Errata

Applies to IP65 step motors from pilot production build

Motors with orange, orange/white, red, red/white, black, black/white, yellow, yellow/white.

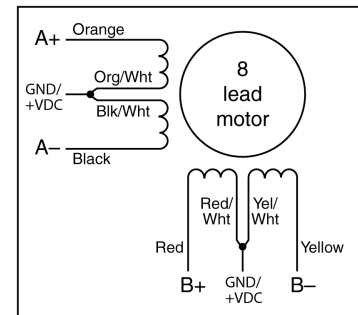
1. Some units have cables that are rated 80°C. These motors should be operated such that the case temperature does not exceed 80°C.
2. The wire colors may differ from our standard. See wiring diagrams below and on the back.
